# Officer Recommendation Report - Householder (extension)

148 Birstall Meadow Road, Birstall. LE4 3NF

Proposed single storey extension to side and rear of existing dwelling to provide sunroom

**P/21/1418/2**

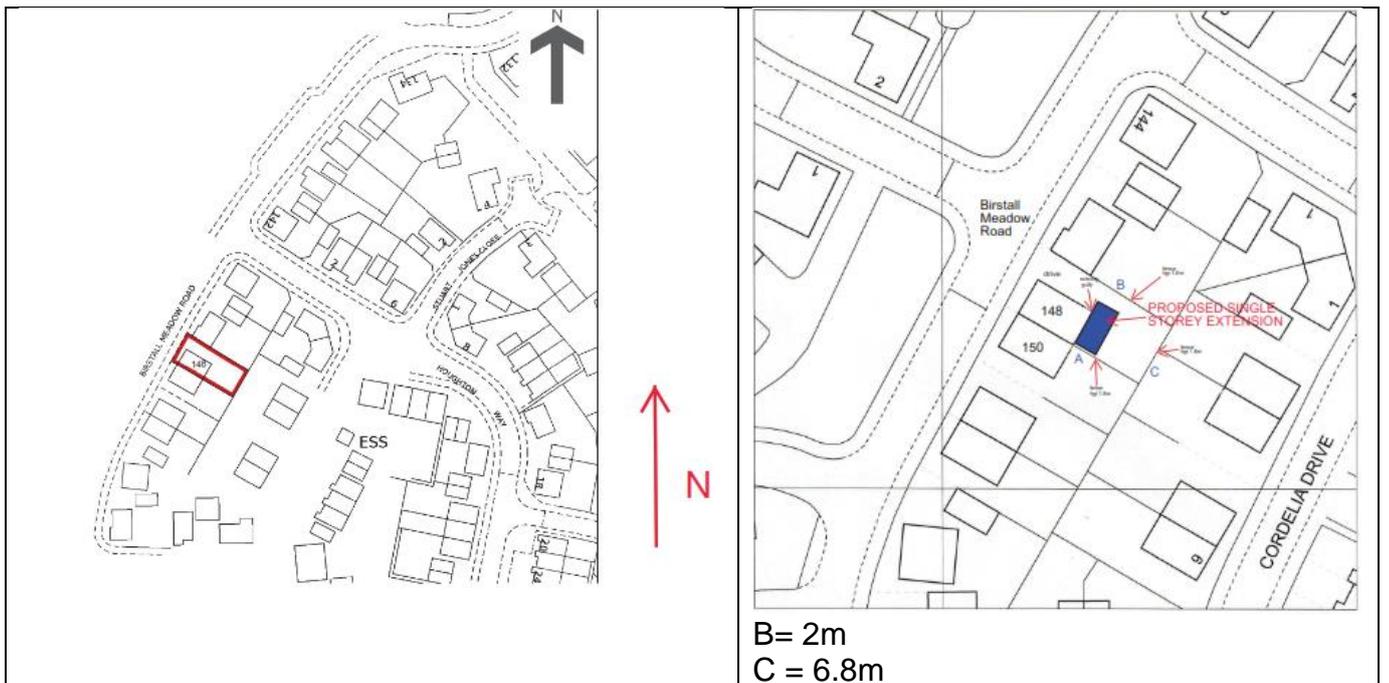
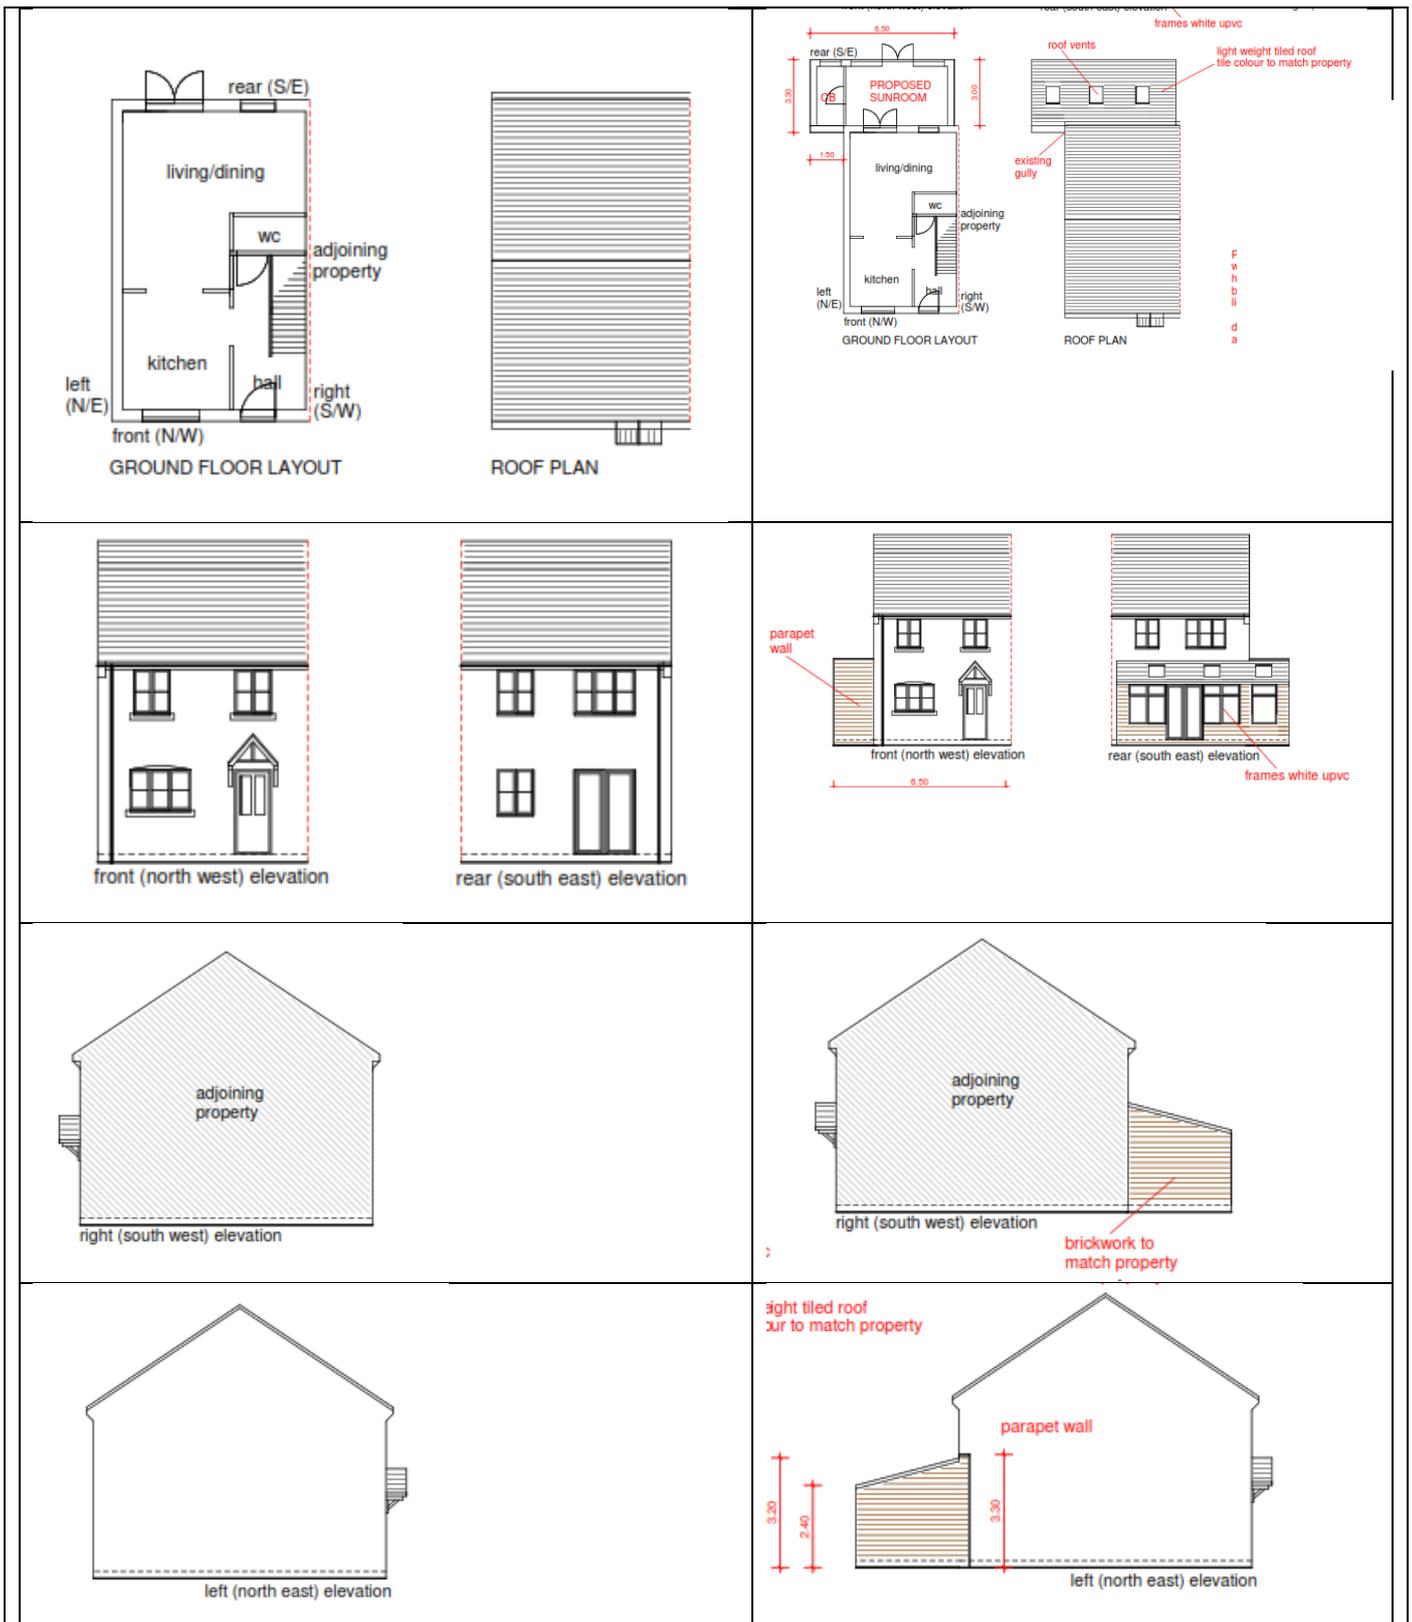
This application seeks permission for a single storey extension to the rear of the existing dwelling. This will take the width of the existing dwelling and extend to the side, having a total width of 6.5m and projecting 1.5m beyond the side of the existing dwelling. The extension will have a monopitch sloping roof with 3 no. rooflights with a height to eaves of 2.4m and maximum height to ridge of 3.2m. The extension will be 3m deep and is brought away from the mutual boundary with the adjoining dwelling at 150 Birstall Meadow Road by 0.15m.

The extension will be constructed using brickwork and tiles to match the existing dwelling and will provide a sunroom with storage cupboard.

The proposed extension meets the 45 degree tests as set out in the Council's SPD on Design and therefore will not result in material harm to the daylight currently enjoyed by the residents of neighbouring properties. Being single storey in height it will not result in loss of privacy or overlooking and will not result in a harmful impact on outlook.
